ADDENDUM

SUBJECT: Pyrometer Thermocouple Installation Warning

APPLICATION: Fixed Orifice and PRXB™ Exhaust Brakes
2003 and Newer Dodge Trucks with 3.5" and 4" Exhaust
***5.9 Liter Cummins Only**

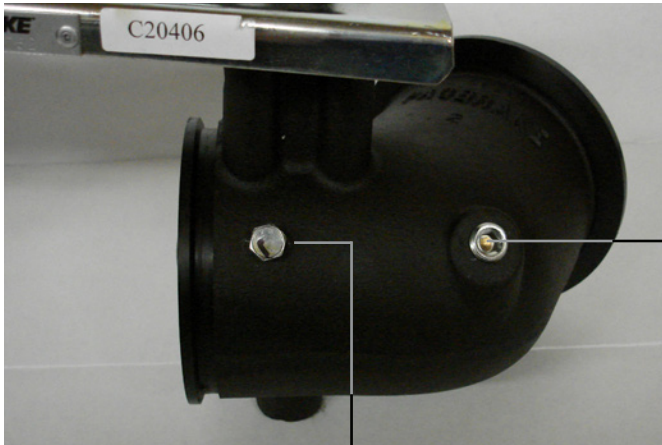
Do not install a pyrometer thermocouple in the back pressure test port, damage to the thermocouple will result.

Pyrometer Thermocouple Port
1/4" NPT

Back Pressure Test Port
1/8" NPT
